FIELD CHANGE ORDER

NUMBER: DS-650Q8-F001

PROBLEM & SYMPTOM: Cross-talk problem between Dispatcher cable and switched cable. Revision incompatibility problem between M7764-00 and M7763-00 module
(Continued on Page 3)

Quick Check: (Continued from Page 1)

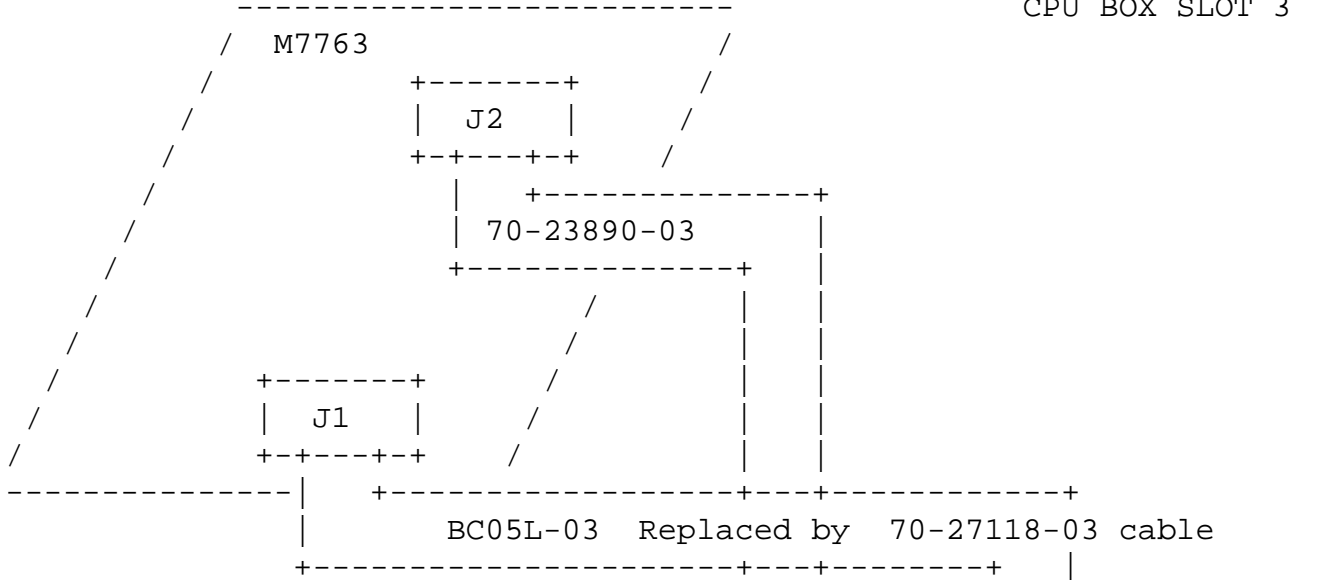
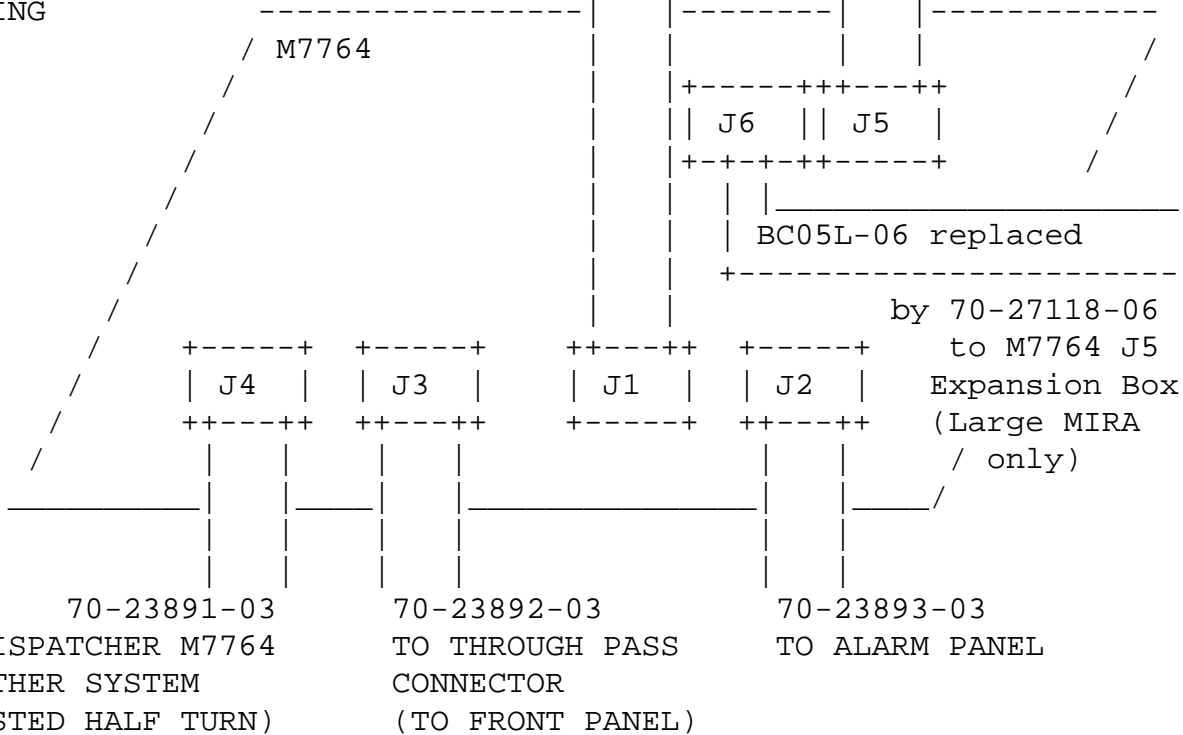
If all the cables on the watch-dog module M7763-00 are flat cables this FCO is required.

If you find a round cable (70-27118-03) connected to the M7763, the module is at the correct Revision (E), and the FCO is not required.

WATCH DOG MODULE TO BE REPLACED

DISPATCHER MODULE TO BE REPLACED

Replace all modules M7763 and M7764 at Revision D or below by new modules at Rev. E and replace BC05L dispatcher cables at one time.
